# HISTORIC AND DESIGN REVIEW COMMISSION

August 19, 2015

**HDRC CASE NO:** 2015-320  
**ADDRESS:** 1515 MISSION RD  
**LEGAL DESCRIPTION:** NCB: 20 LOT: 22, 22B, 22C, 22D & 37 NCB: 24 P-100A NO LABEL# NO SERIAL# CR#2012-25965//2013-RESURVEY PER DEED 15737/22212 EX 10/5/2012  
**ZONING:** IDZ H RIO-4  
**CITY COUNCIL DIST.:** 3  
**DISTRICT:** Mission Historic District  
**APPLICANT:** White Conlee Builders, Ltd  
**OWNER:** White Conlee Builders, Ltd  
**TYPE OF WORK:** Construction of five, three and four story apartment buildings  
**REQUEST:**

The applicant is requesting conceptual approval to construct a multifamily apartment complex containing five, three and four story buildings, a two story clubhouse, surface parking and various amenities. The proposed development will be built on approximately thirteen of twenty undeveloped acres.

01 EXTERIOR ELEVATION  
CLUB HOUSE - FRONT  
CLUB HOUSE - FRONT  
SCALE: 1/8" = 1'-0"

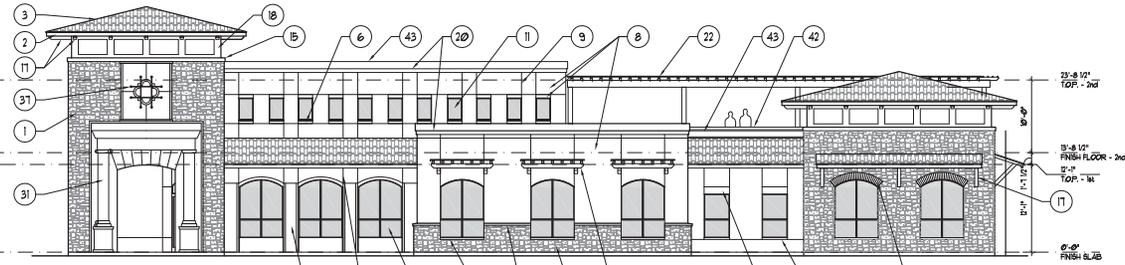
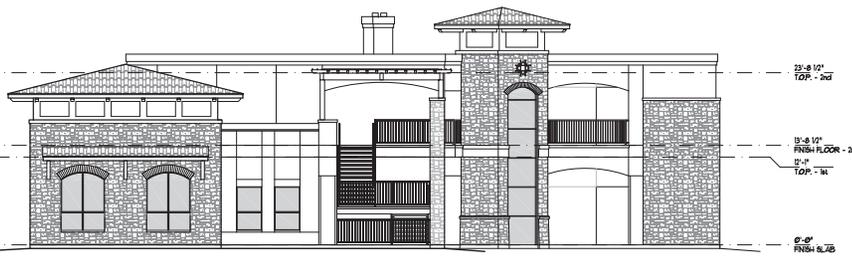
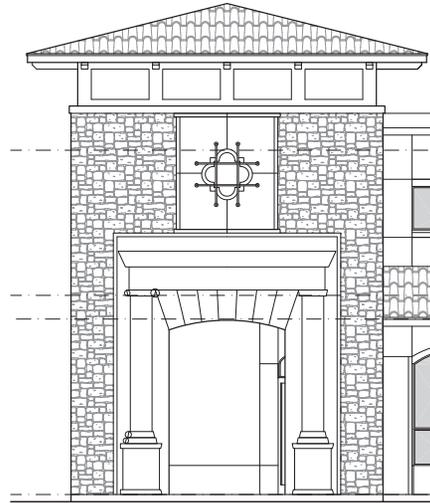
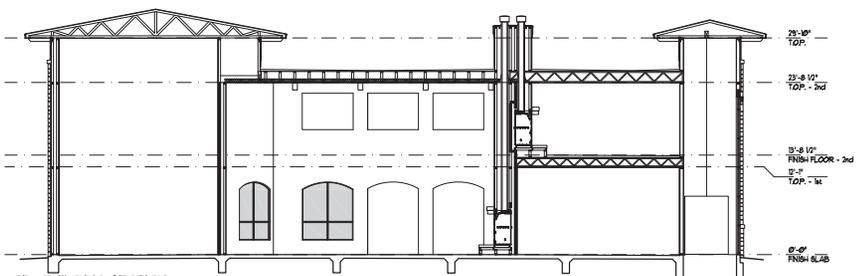
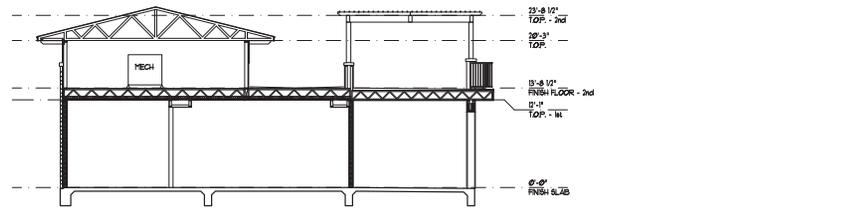
- y. The applicant has proposed a façade composition that features three distinct façade segments; a base, midsection and cap, each separated by a change in materials or architectural feature. This is consistent with the UDC Section 35-674(e).

- z. Regarding architectural details, new building should be designed to reflect their time while respecting the historic context of their surroundings. New construction should incorporate contemporary interpretations of vernacular architecture while presenting a design that features materials that are used in the correct context and scale. The applicant has proposed simulated stone veneer and cement tile roofing that while being consistent with the UDC regarding materials are used in a scale which is not traditionally found. The use of these materials in combination with the number and placement of the proposed arched openings presents a design that staff finds is not appropriate.
